Product Change Notice
(PCN Tracking Number: EE-QR-220914-01)
Version: 1

Customer:	ALL Customers
Renesas Product Type:	RZ/G2L, RZ/V2L series
Description of Change:	Addition of assembly outsourcing site (OS) & package substrate change
Reason for Change:	To ensure stable supply and improve productivity
Identification:	Identifiable via assembly lot code on the package and also by SPN on label. (Details are shown on pages 2-3)
Schedules:	Reliability report: m/o Dec. 2022 (upon request) Requested approval m/o Mar. 2023 Change implementation e/o Mar. 2022 onwards
Anticipated Impact:	Fit, Form & Function: No impact Quality & Reliability: No impact
Doc. No.:	EE-QC-PCN-CR-22-0169
Internal Reference:	EPMP-IMB-22-0199-1

- a) Package top view

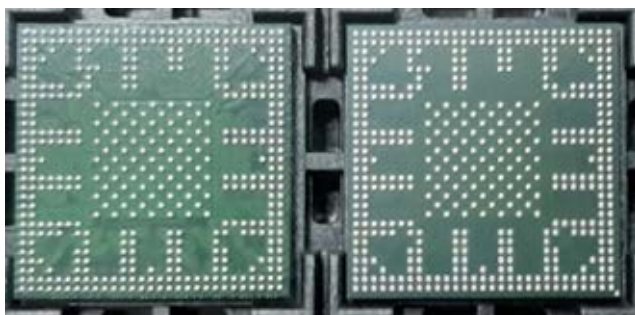
There are differences in mold color and laser mark font/color due to OS standard process

Additional OS site B vs. Current OS site A

- b) Package bottom view

Additional OS site B vs. Current OS site A
